The Yucca Mountain Quality Assurance Division (YMQAD) completed its review and acceptance of the Reynolds Electrical & Engineering Company, Inc. (REECo) Change Notices 91-01, 92-01, and 92-02 to the REECo Quality Assurance Program Plan (QAPP), 568-DOC-115, Revision 8.

## CHANGES/REVISIONS TO PARTICIPANT QUALITY ASSURANCE (QA) PROGRAM DESCRIPTIONS

| REECO<br>YUCCA MOUNTAIN PROJECT<br>QAPP CHANGE NOTICE |                          | QAPPCN No. 91-01   | Date:          |

Figure 2

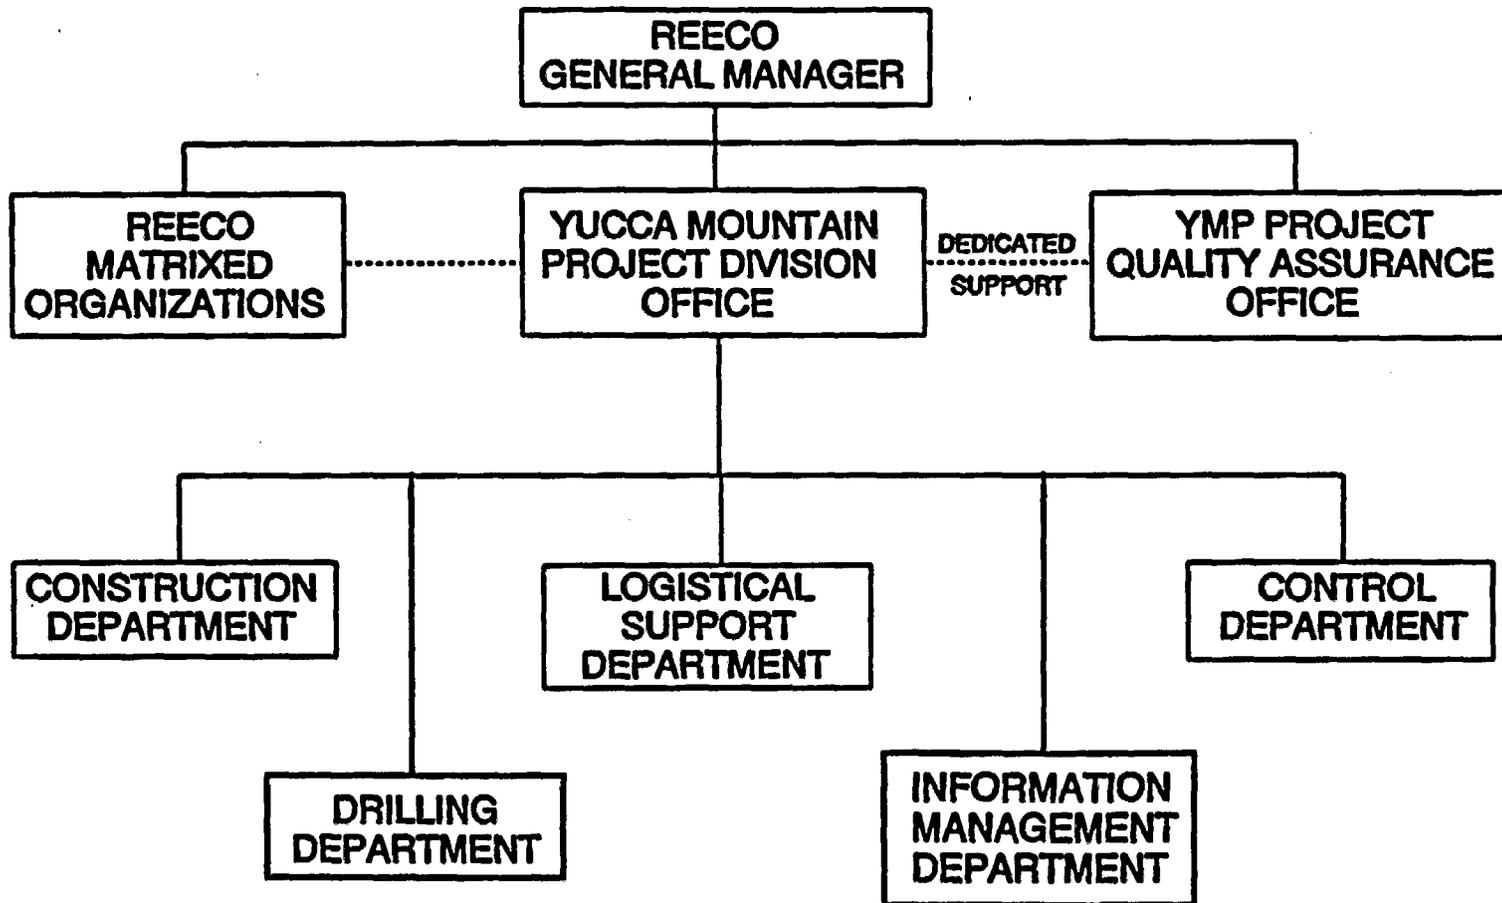
| REECO<br>YUCCA MOUNTAIN PROJECT<br>QAPP CHANGE NOTICE |                                  | QAPPCN No. 91-01   | Date:          |
|---|----------------------------------|--|----------------|
| I-9   | figure 2                         | Delete figure 2, page I-9 and replace with new figure 2 of this change notice, QAPPCN No. 91-01.   |                |

Figure 3

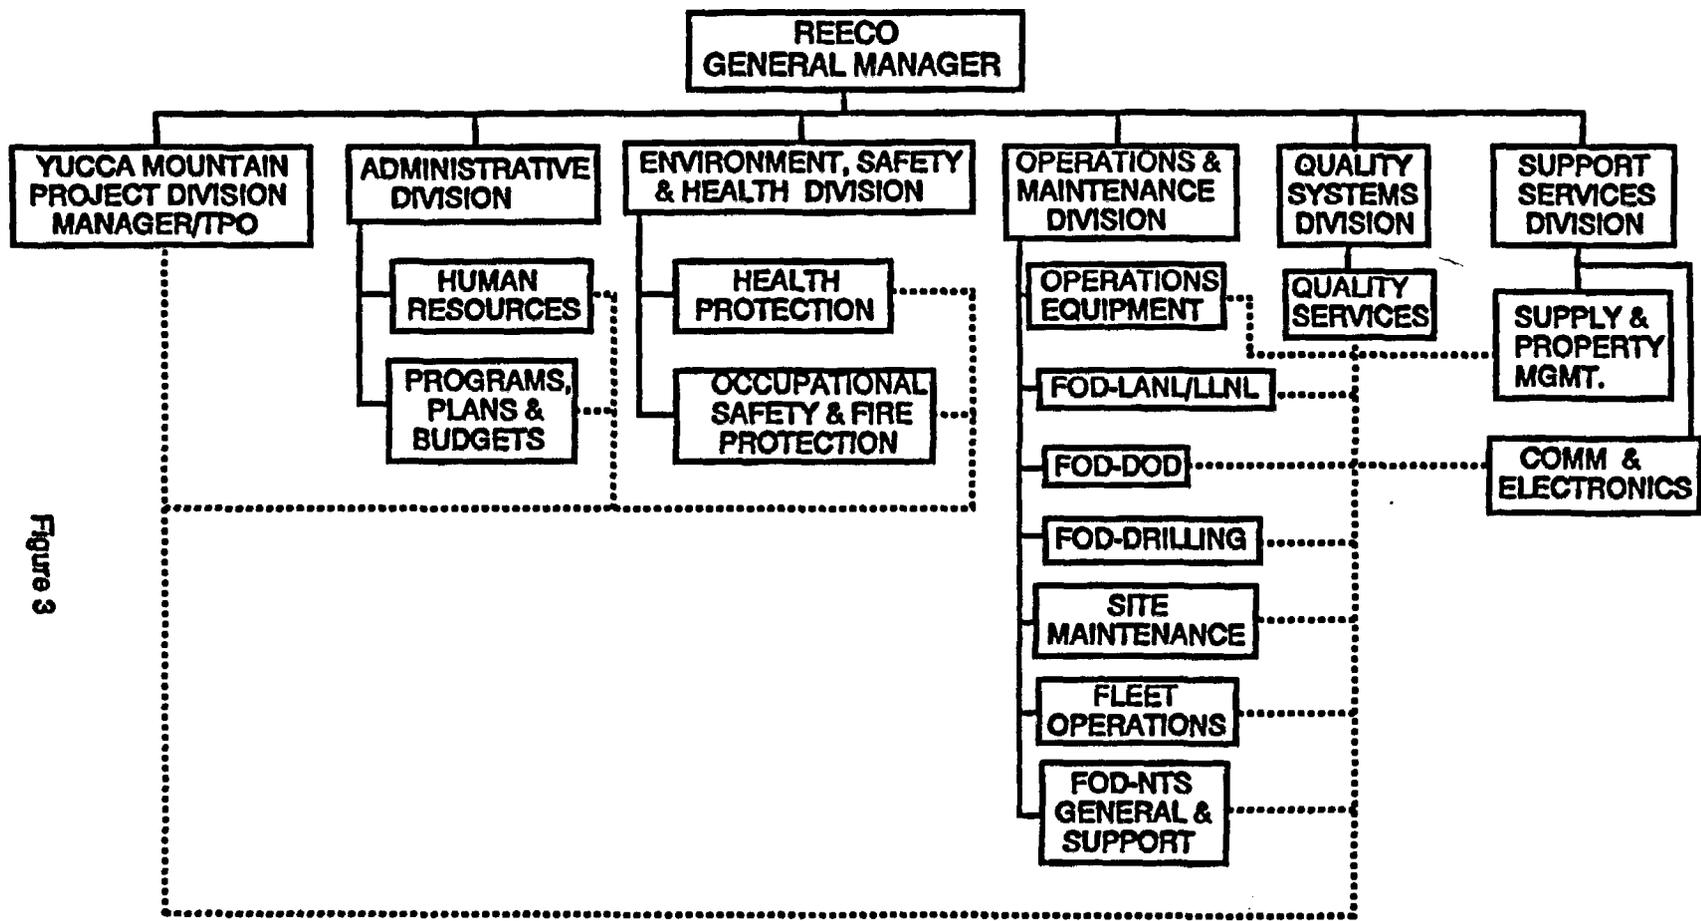
| REECO<br>YUCCA MOUNTAIN PROJECT<br>QAPP CHANGE NOTICE |                          | QAPPCN No. 91-01   | Date:          |
|---|--------------------------|--|----------------|
| I-1   | sec. 1.0<br>para. 3      | Add sentence to end of paragraph, to read:<br>"Figure 3 further shows the relationship of the matrix support organizations."   |                |

| REECO<br>YUCCA MOUNTAIN PROJECT<br>QAPP CHANGE NOTICE |                                  | QAPPCN No. 91-01   | Date:          |
|---|----------------------------------|--|----------------|
| I-10  | figure 3                         | Delete figure 3, page I-10 and replace with new figure 3 of this change notice, QAPPCN No. 91-01.  |                |
